REGULATION NO. 91. UNIFORM PROVISIONS CONCERNING THE
APPROVAL OF SIDE-MARKER LAMPS FOR MOTOR VEHICLES AND THEIR
TRAILERS

PROPOSAL OF AMENDMENTS TO REGULATION

TRANS/WP.29/733

DRAFT SUPPLEMENT 3 TO REGULATION No. 91

Annex 3, Example 1 (a), amend to read:

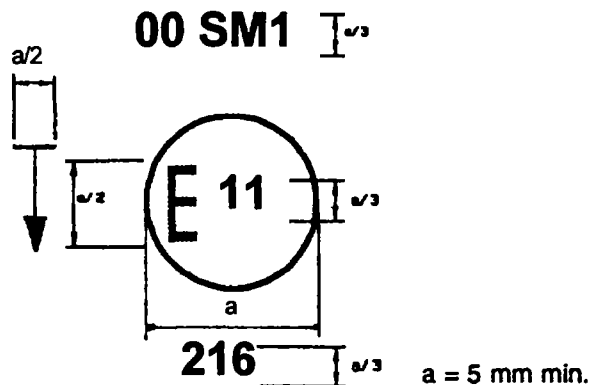
Annex 3, add a new sentence at the end of the caption below the figure, to read:

".... number 216. The vertical arrow starting from a horizontal segment and directed downwards indicates a permissible mounting height of equal to or less than 750 mm from the ground for this device.
